Appl. No. 10/805,179
Amdt. dated November 3, 2005
Reply to Office Action of August 9, 2005

Atty. Ref. 81754.0117
Customer No. 26021

Amendments to the Drawings

Remarks/Arguments

FIG.6

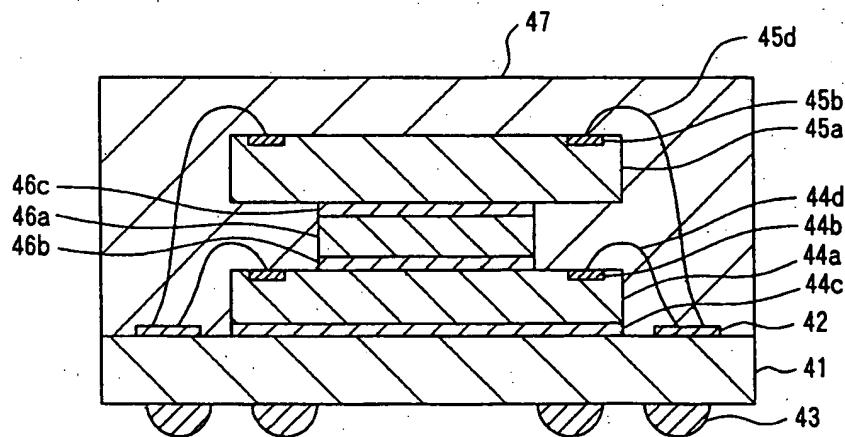
Figure 6 is objected to under MPEP 608.02(g) as lacking the legend --Prior Art--. In response, Figure 6 is amended to include the legend --Prior Art--. A replacement drawing sheet and an annotated sheet showing changes are attached.

The drawings are objected to under 37 CFR 1.84(p)(4) because reference characters 44a and 46a have both been used to designate the mirror chip. In response, applicant notes that in Figure 6, reference character 44a properly designates the lower semiconductor chip while reference character 46a designates the mirror chip. However, in one location in paragraph [0003] of the specification, mirror chip 46a is mistakenly referred to as semiconductor chip 44a. Paragraph [0003] is amended to correct this error, thereby overcoming the objections to the drawings.

The drawings are further objected to under 37 CFR 1.84(p)(4) because reference characters 44b has been used to designate both an electronic pad and a semiconductor chip. In response, applicant notes that in Figure 6, reference character 44b properly designates only the electronic pad. However, in one location in paragraph [0004] of the specification, semiconductor chip 45a is improperly designated as “44b”. Paragraph [0004] is amended to correct this error, thereby overcoming the objections to the drawings.

The attached sheet of drawings includes changes to Figure 6. This sheet, which includes Figure 5, replaces the original sheet including Figures 5 and 6. In Figure 6, the legend --Prior Art-- has been added.

"PRIOR ART"
